**Before the
FEDERAL COMMUNICATIONS COMMISSION
Washington, D.C. 20554**

In the Matter of)	
)	
Digital Audio Broadcasting Systems)	MM Docket No. 99-325
And Their Impact on the)	
Terrestrial Broadcast Service)	
)	
)

REPLY COMMENTS OF THE WALT DISNEY COMPANY AND ABC, INC.

FIGURE 1 – Arrangement of the Data Ensembles for the AM Hybrid System

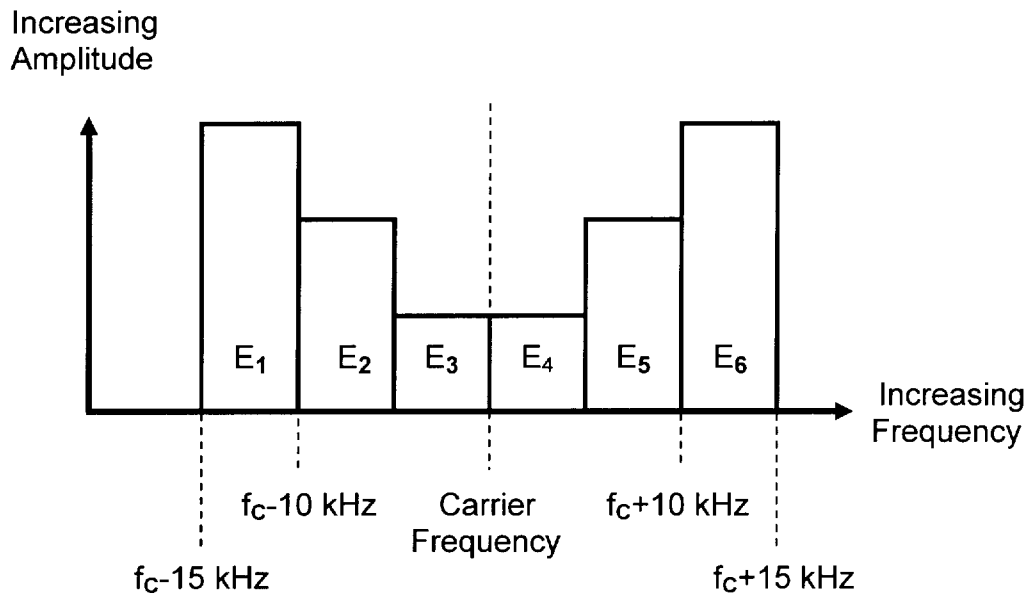
The present system has digital sidebands which extend from 15 kHz below the carrier frequency of the transmitting station to 15 kHz above the carrier frequency. Figure 1 shows the proposed arrangement of the digital signals. There are six data ensembles. Each is 5 kHz wide. The power transmitted in some ensembles is greater than in others.

Clear Channel recommends that the Commission approve the presently proposed AM system with the exception that the power in the "primary sidebands" should be reduced by at least 6 dB. The "primary sidebands" are those sidebands which are removed from the carrier frequency by more than 10 kHz but less than 15 kHz (See digital ensembles E₁ and E₆ in Figure 1).

FIGURE 2 – Interference Mechanism In The First-Adjacent Channel, Digital-Into-Analog Case

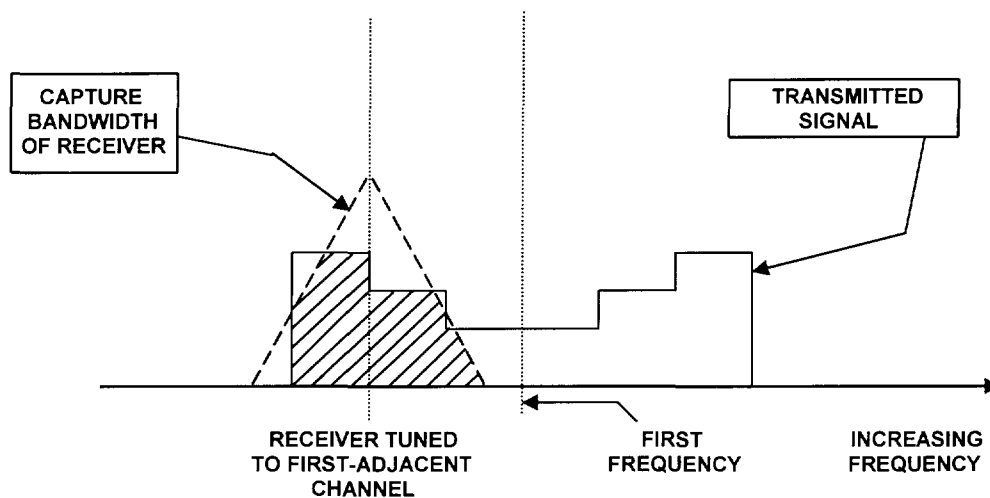
In its comments, Clear Channel correctly points out that, because the new digital signal is wider than the 10 kHz analog signal presently permitted by 47 C.F.R. § 73.44(b), the digital signal actually is “co-channel” to stations which are 10 kHz removed in carrier frequency (Figure 2). FCC allocation standards are based on a firm presumption that the highest power density of an AM station will be near its carrier. That presumption is not correct with the proposed system. Therefore, sufficient spacing between stations for digital operation may not be provided by 47 C.F.R. § 73.37 and 47 C.F.R. § 73.182 as presently written.

Figure 2 shows that the majority of the digital signal which is captured by a legacy analog receiver is in the “primary” sidebands. The interference contribution of the “secondary” sidebands (those removed from the carrier frequency by more than 5 kHz but less than 10 kHz) is much smaller. Reducing the power in the primary sidebands reduces the audio interference into legacy receivers by an amount almost equal to the sideband reduction. By contrast, reducing the power in the secondary sidebands would have little effect, as any power reduction of the secondary sidebands would be masked by the remaining primary sidebands.

FIGURE 3

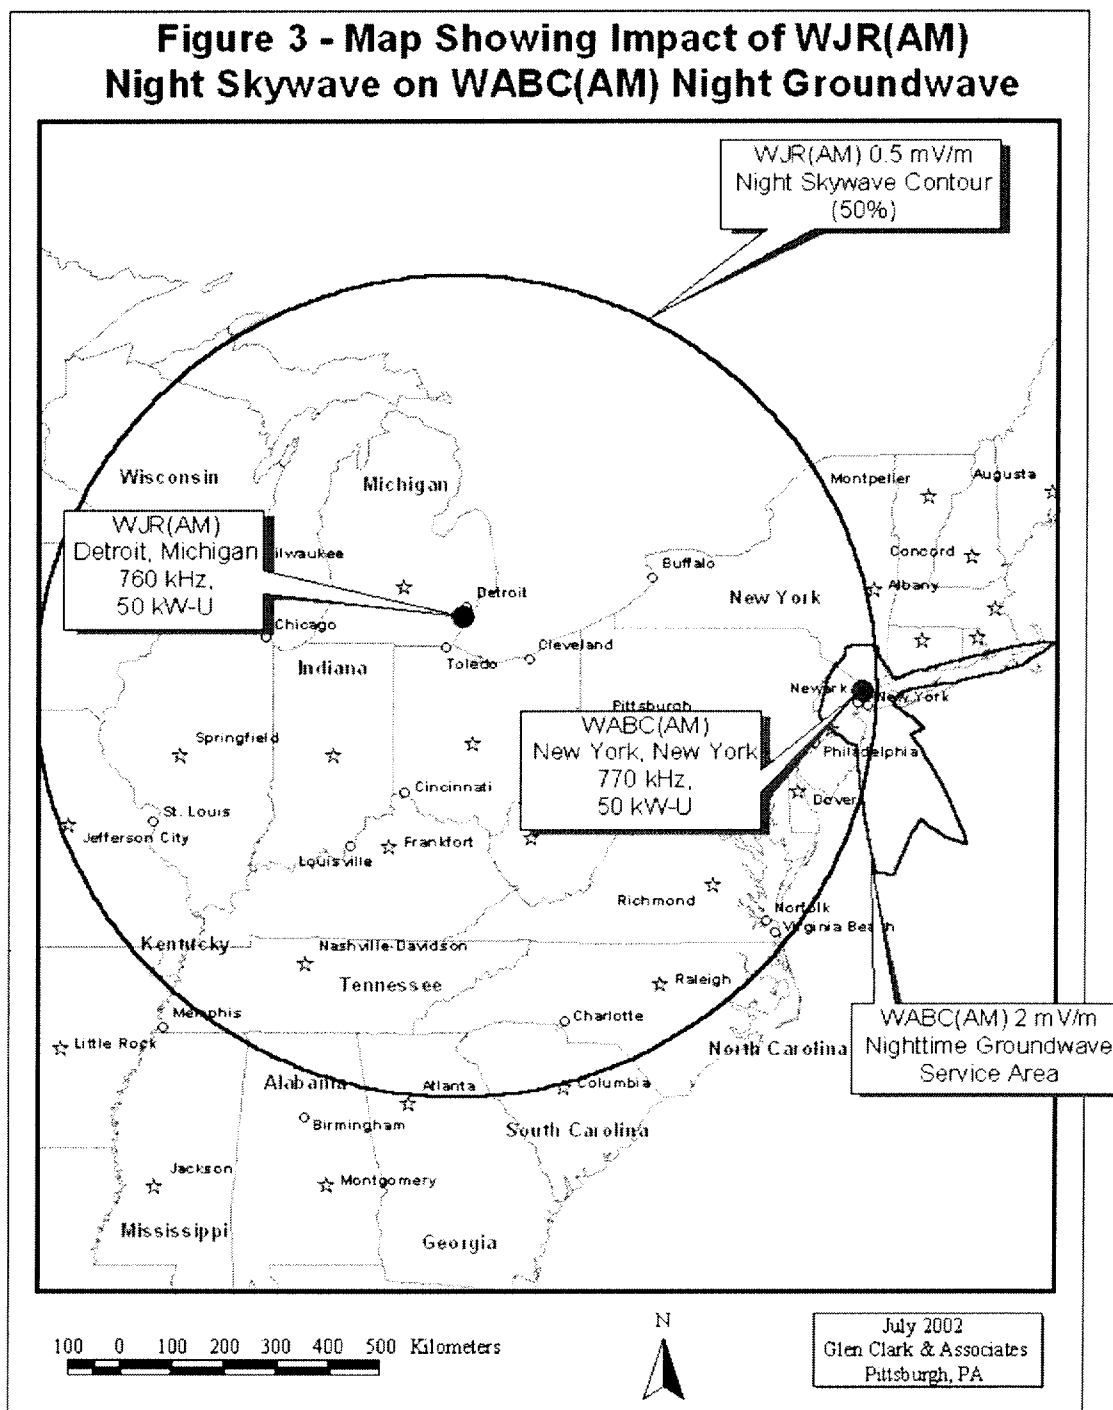
The attached Figure 3 shows the relationship between WJR(AM), Detroit and WABC(AM), New York City. WJR operates on 760 kHz. WABC operates on 770 kHz.

Figure 3 shows that WJR places a 0.5 mV/m service contour⁴ over New York City at night. As digital portions of the IBOC spectrum would be present between 765 and 775 kHz, the WJR signal would fall within the passband of receivers in the New York area attempting to listen to WABC. Ironically, ABC owns both stations. The attached Figure 4 demonstrates that the inverse is also true. An IBOC signal transmitted by WABC would interfere with WJR in Detroit. WABC and WJR would interfere with each other even though they are co-owned.

⁴ This is not a "10% contour," as calculated using the method in 47 C.F.R. §73.190(c), which would mean that it is present infrequently. The WJR contour shown in Figure 3 is calculated by the more demanding "50% method" found in 47 C.F.R. §73.190(b). This means that the WJR signal would be present in New York, on average, at least 30 minutes out of every hour.

FIGURE 4

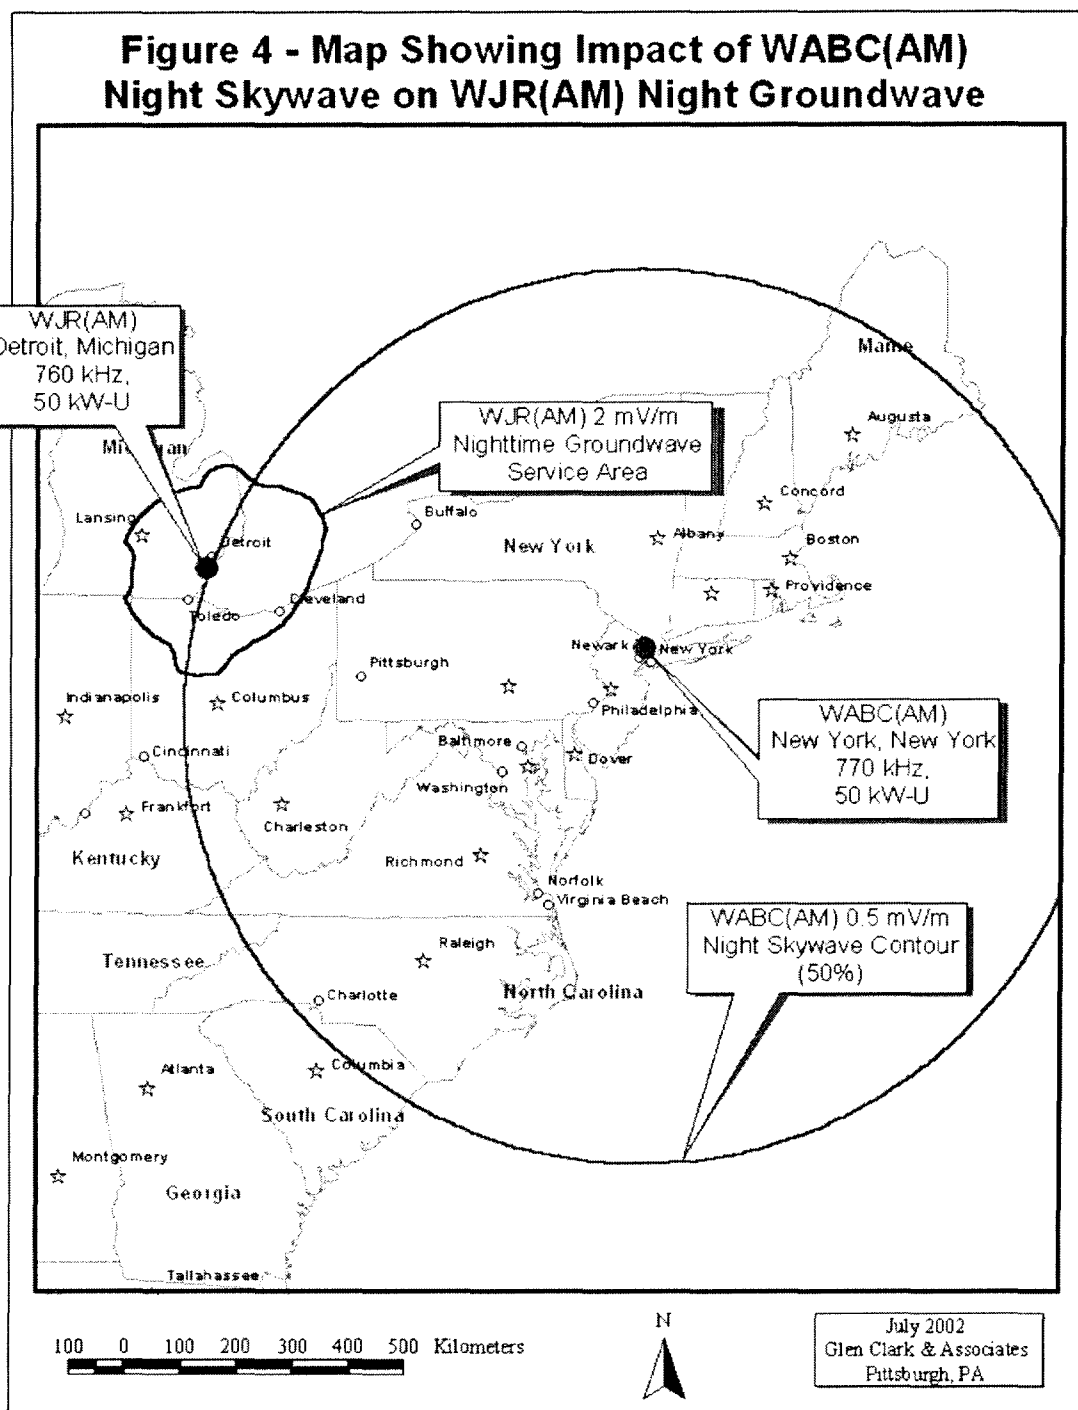
Figure 5 shows a much more severe situation which would confront Disney's Los Angeles KDIS(AM). KDIS operates with 50 kW days and 10 kW nights on 710 kHz. KDWN(AM) operates on 720 kHz in Las Vegas, Nevada, 209 miles away. KDWN operates at night with 50 kW and employs a directional antenna which increases the signal in the Los Angeles area. Figure 5 shows that KDWN places a 2 mV/m skywave service contour over all of Los Angeles at night. As before, this is a "50% contour", not a "10% contour". 2 mV/m is a strong signal in this context. Were it not for the presence of KDIS, the KDWN skywave signal would be very listenable in many parts of the Los

Angeles area. ABC believes that the adoption of the present AM IBOC standard would lead to objectionable interference to its station in Los Angeles at night.
